### Lunar Module (LM) Apollo Operations Handbook

**LMA790-3-LM 4**  
**APOLLO OPERATIONS HANDBOOK**

5.2.1 GUIDANCE, NAVIGATION, & CONTROL SUBSYSTEM

A-300LM4-592

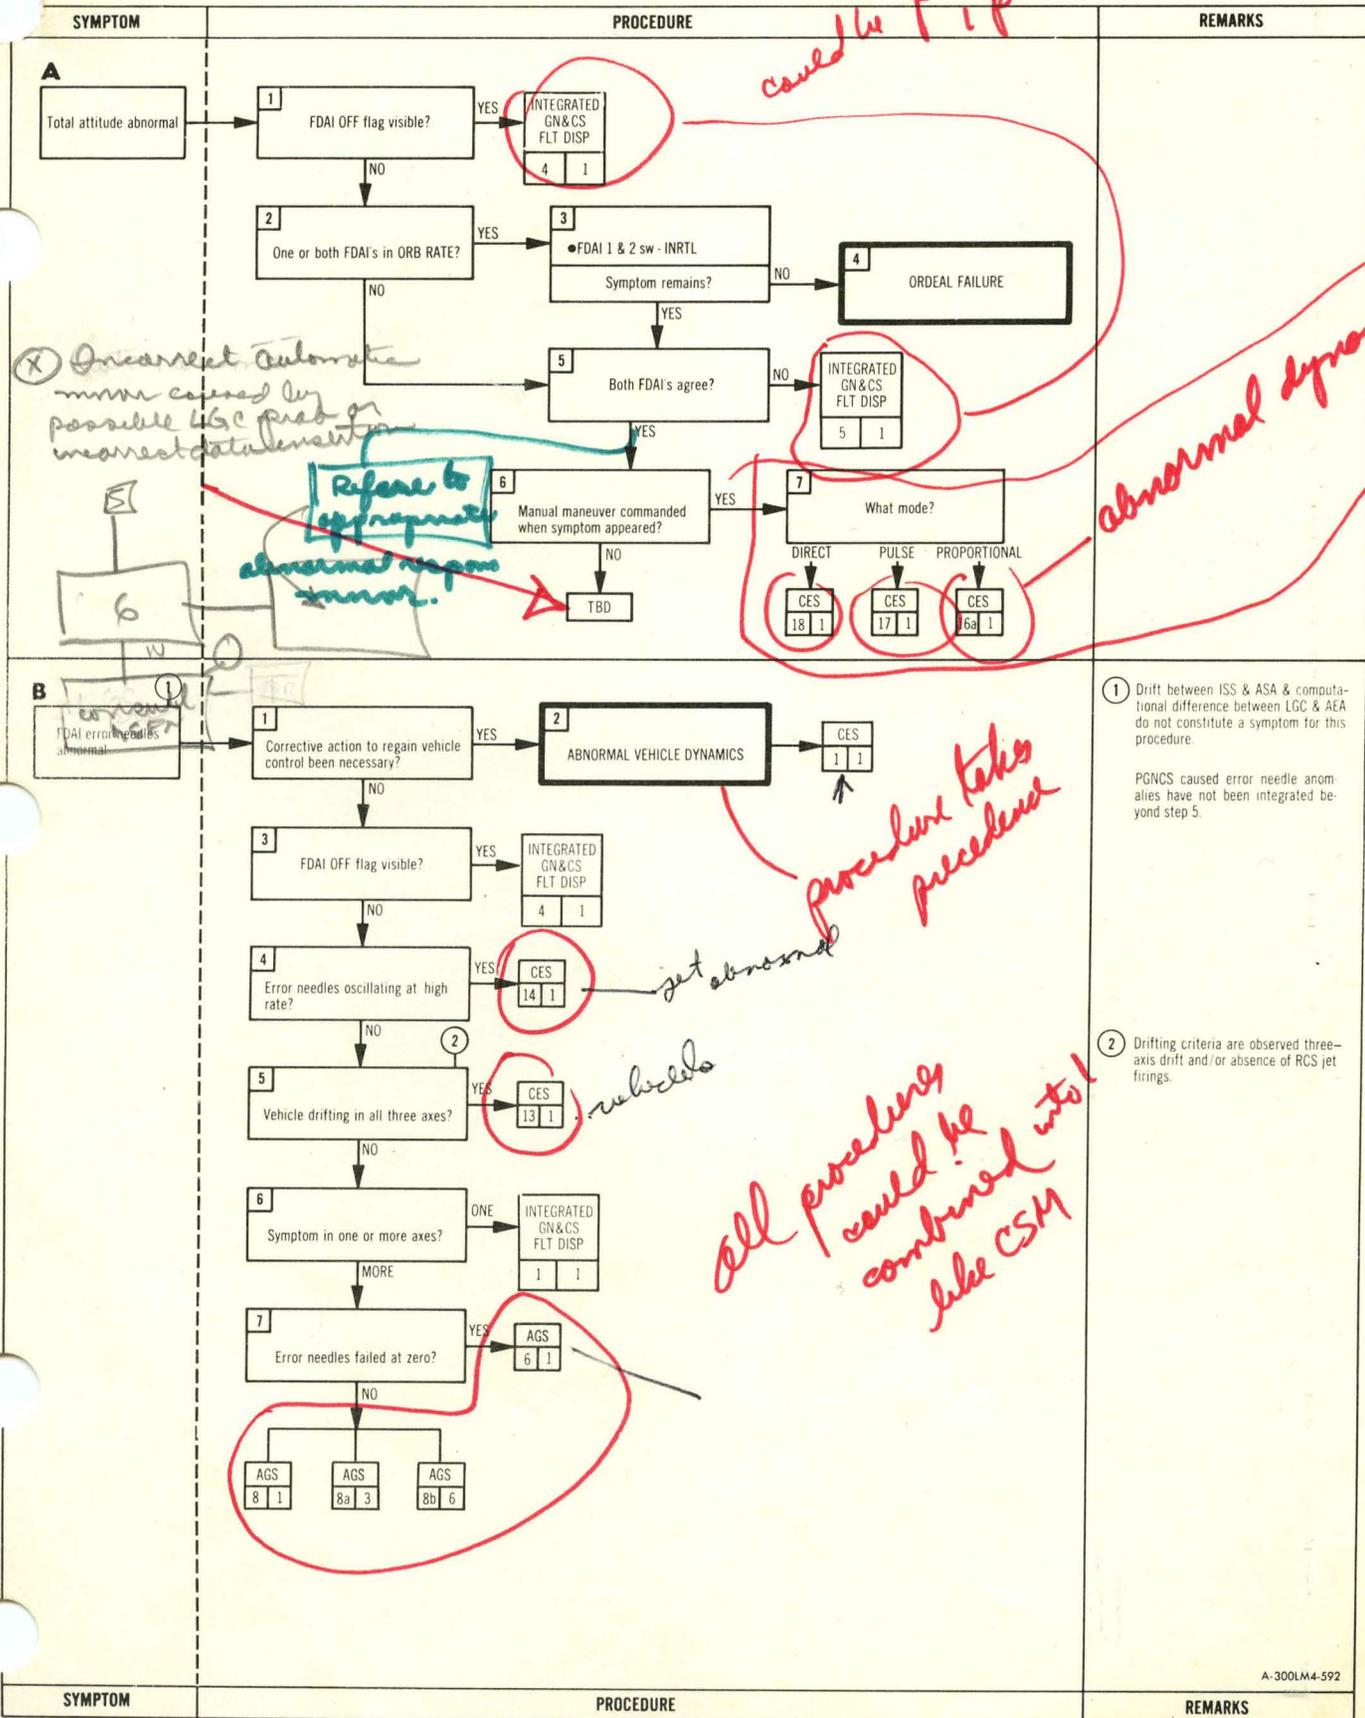
*Incorrect Autorate error caused by possible LGC prob or incorrect data sensitivity*

*Refer to appropriate abnormal response man.*

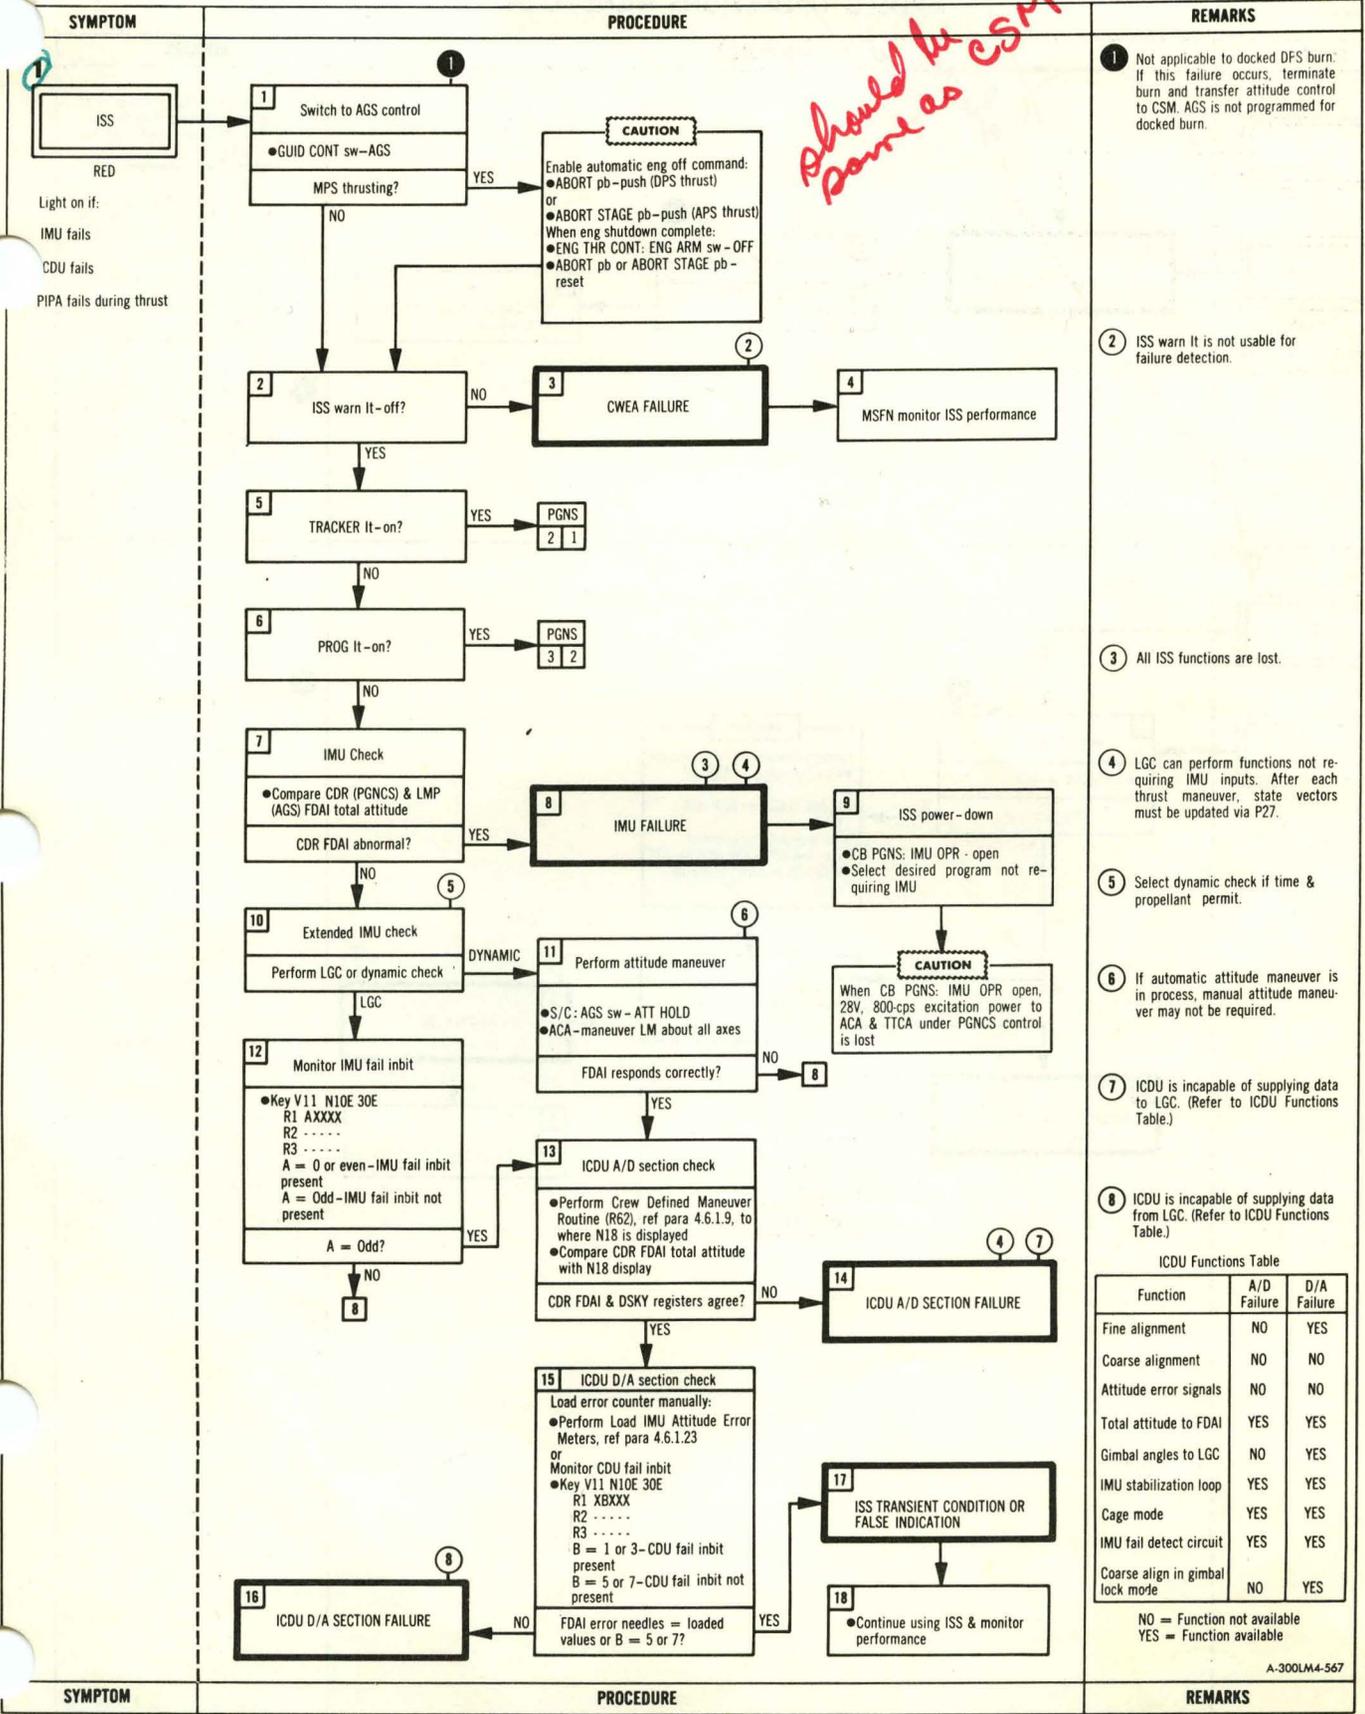
*Should be CSM same as CSM*

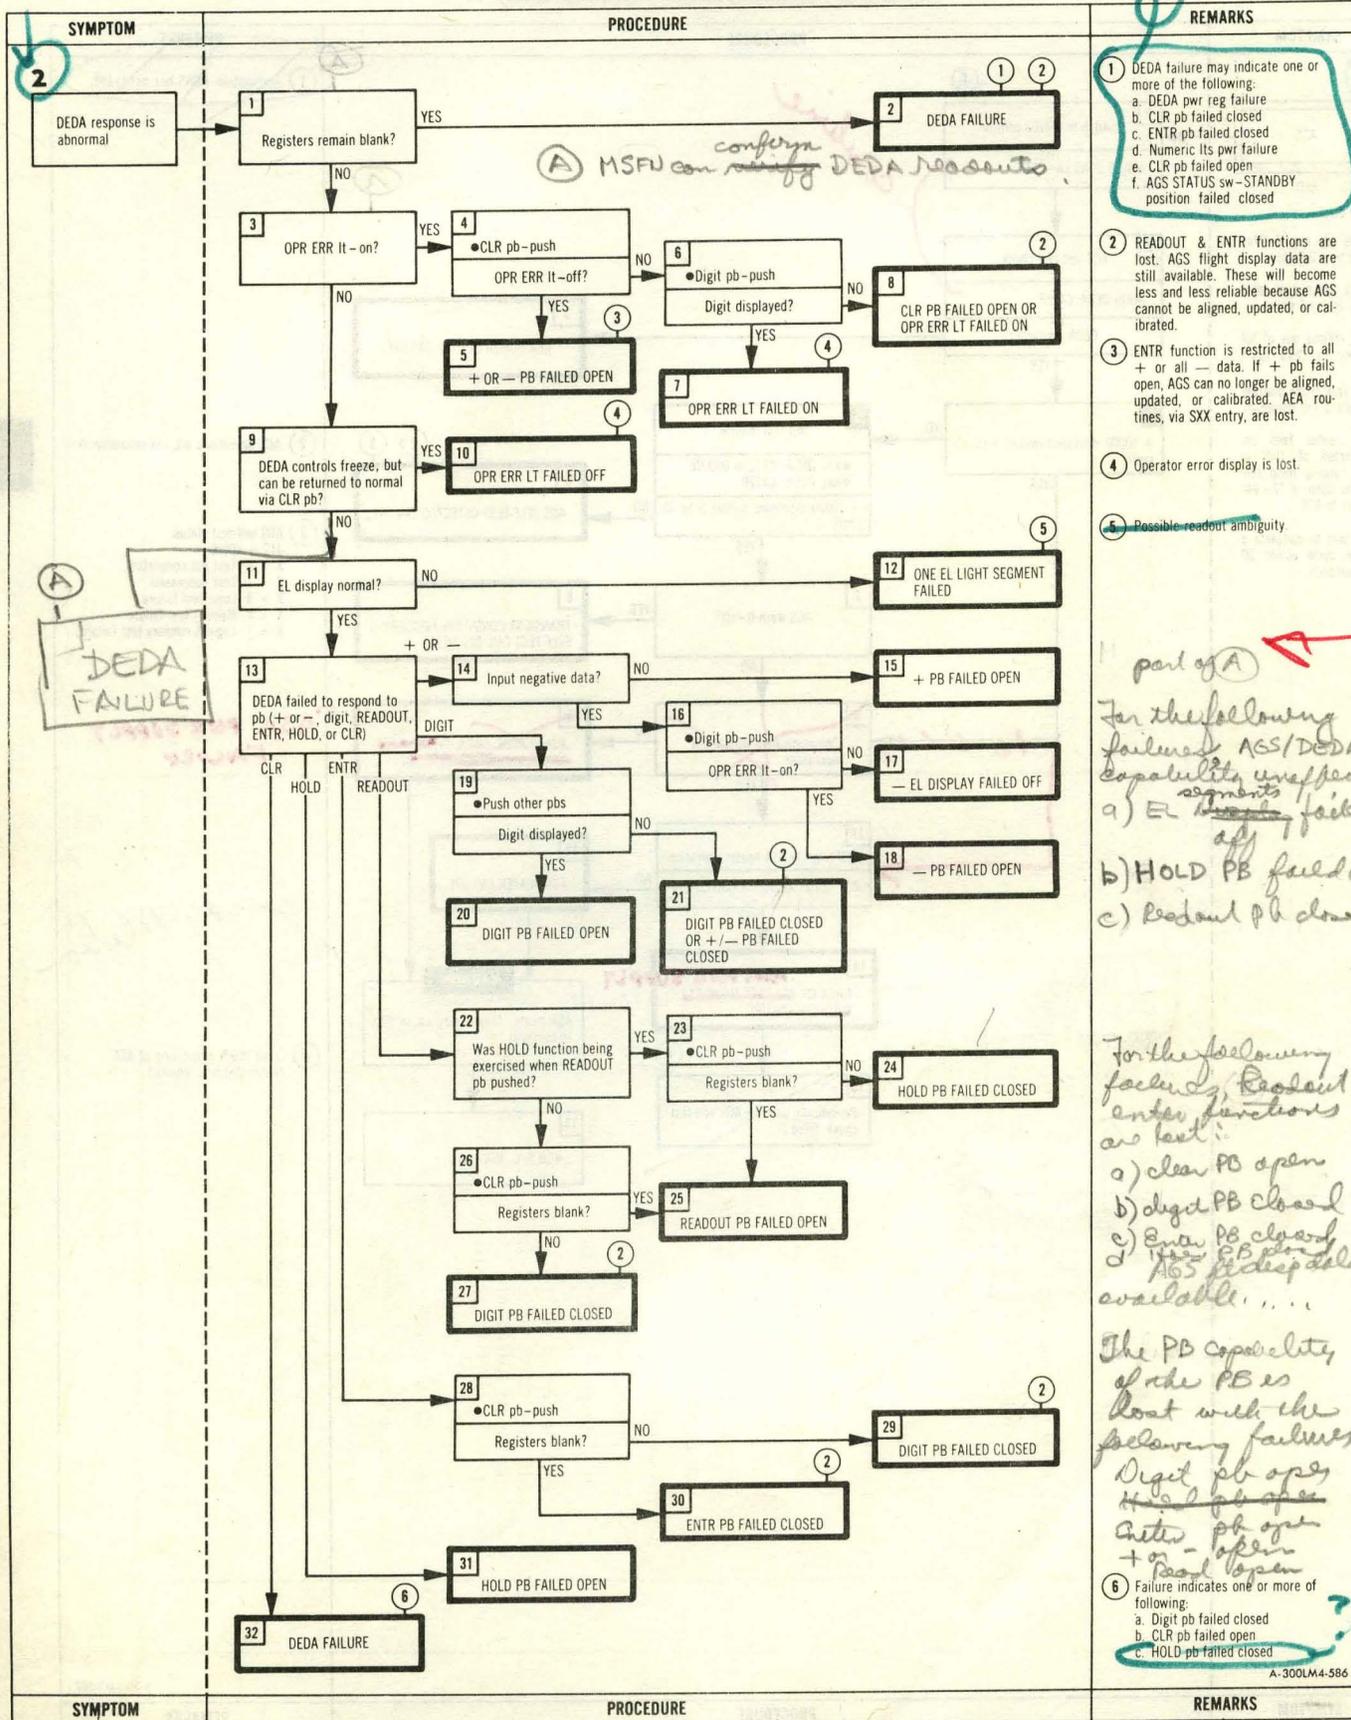
Perform in flight  
 in flight  
 & accel coll

combine

possible deletion

A-300LM4-595-1

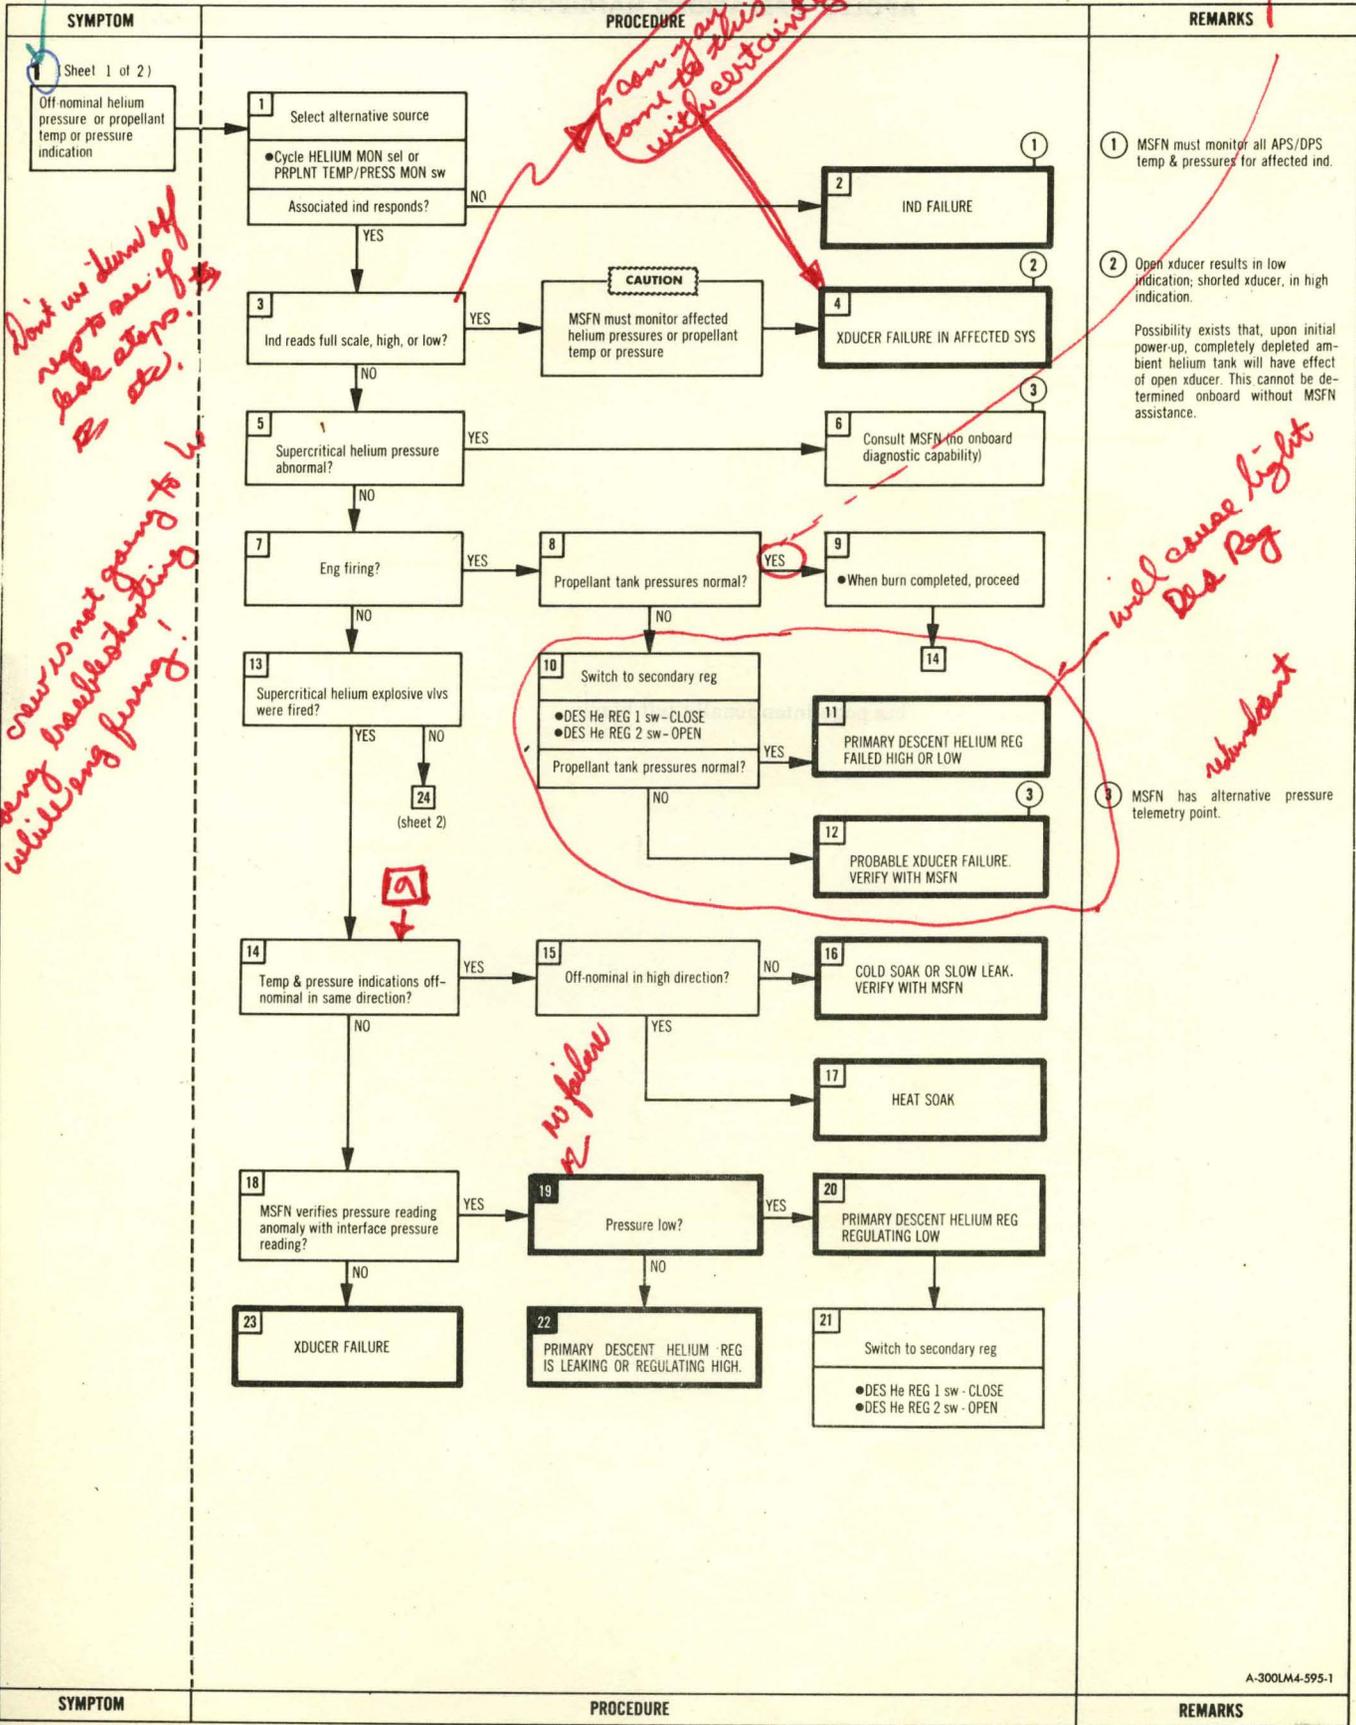
*can't say this conclusion with certainty*

*Don't we dim off  
 reports as if  
 back stops etc.  
 crew is not going to be  
 doing troubleshooting  
 while in flight*

*will cause light  
 Des Reg  
 redundant*
